Planning Committee  
21 September 2022

**Report by the Director for Economy**

**Application Number: AWDM/0605/22      Recommendation – APPROVE**

**Proposal: Reserved matters application for Appearance, Landscape, Layout, Scale and access within the site, for 287 new homes (Use Class C3) together with car parking, landscaping and associated works.**

**Fig. 3:  
Apartment  
Zone**

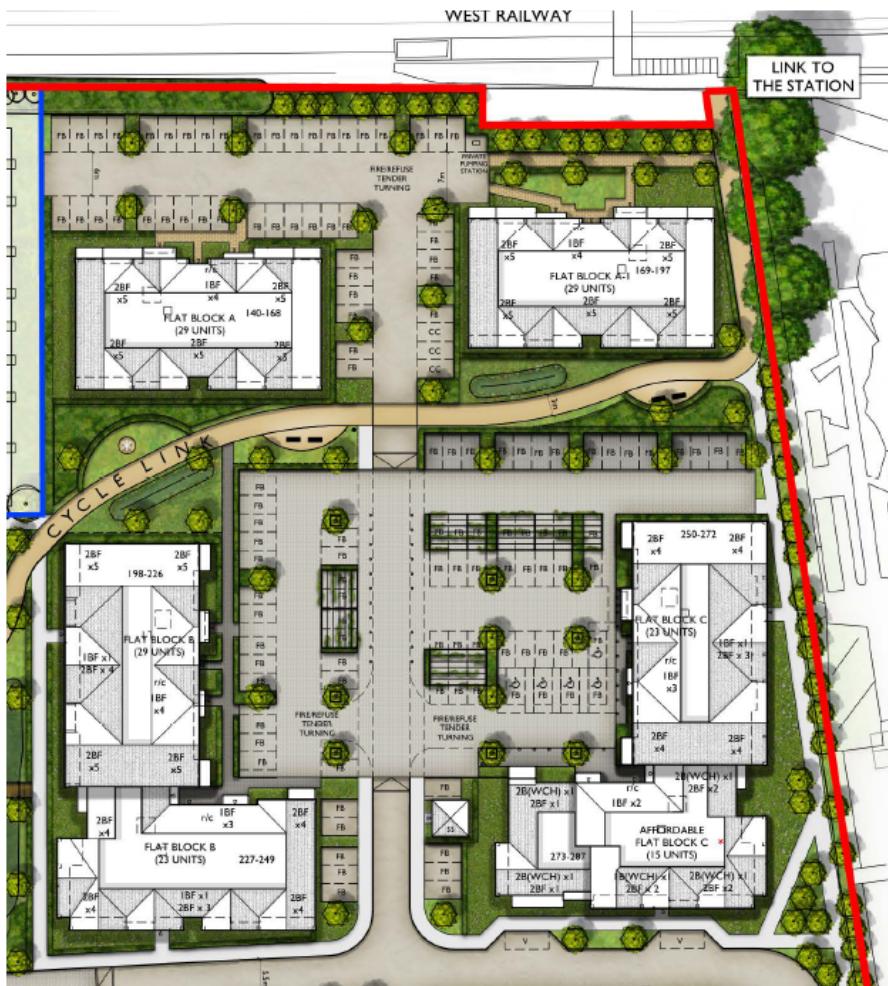
*The apartment zone (Fig.3) comprising four blocks occupies the north east part of the site.*

Figure 13, with the existing Durrington Bridge House in the background, illustrates that the resulting distances between blocks are reasonably successful in creating a sense of space between them, with much reliance on well designed landscaping and its upkeep. The L shaped blocks to the right hand side of the image are separated by 58m, well in excess of the 28m sought in the Design Code. The overall spacing of apartment blocks can be seen in Figure 3 / Appendix 1 of this report.

**Fig 18. Comparative Distances (end of existing 5-storey wing in yellow)**

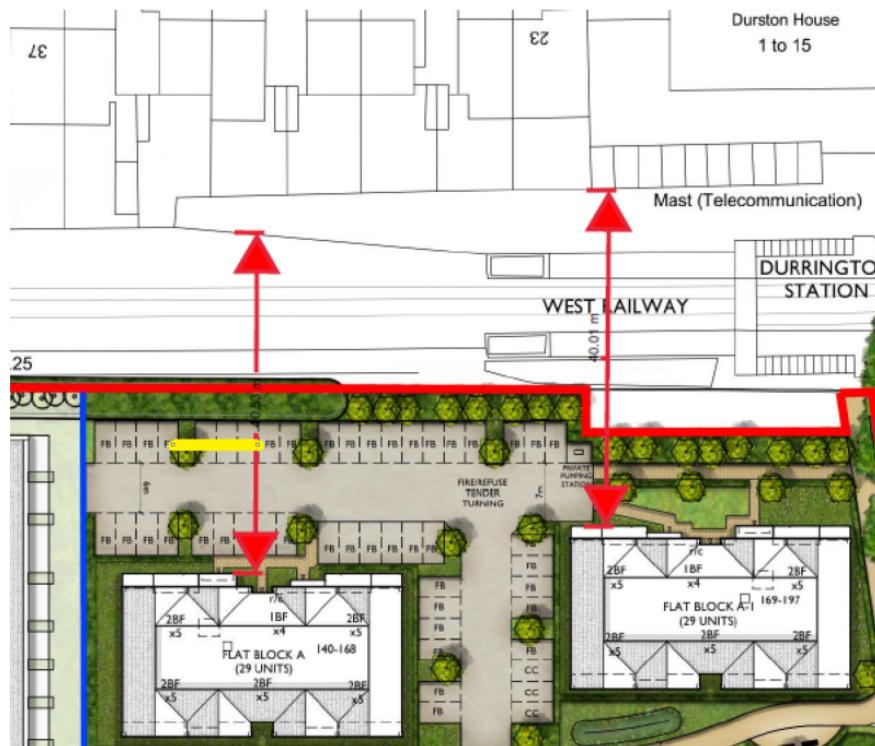
Figure 18 below shows the proposal. Officers have indicated the approximate position of the existing five storey office wing as a yellow line.

It is noted that amended proposals have moved the northern blocks closer to the northern boundary than in the plans originally submitted with this application. This was due to the need to create acceptable spacing in the internal planning of the site.

Inevitably a degree of overlooking would occur which is likely to be greater than that of the existing development, coupled with a marked change of outlook. In considering what might lessen these effects it is also acknowledged that the distances involved are much greater than the 28m separations which were used as a design guide for buildings within the site, arguments regarding privacy and impact on outlook under policy H18 involve a degree of judgement as to what is reasonable.

One consideration is the height of the proposed buildings, which is 3m greater than the existing building, due to the use of pitched roofs, introduced by the amended plans. Officers have asked the applicant to consider whether the roof forms of this northern pair of apartment blocks might be made smaller, flat or partly flat. This may affect the internal design consistency within the site, but the outcome of this suggestion will be reported to the Committee.
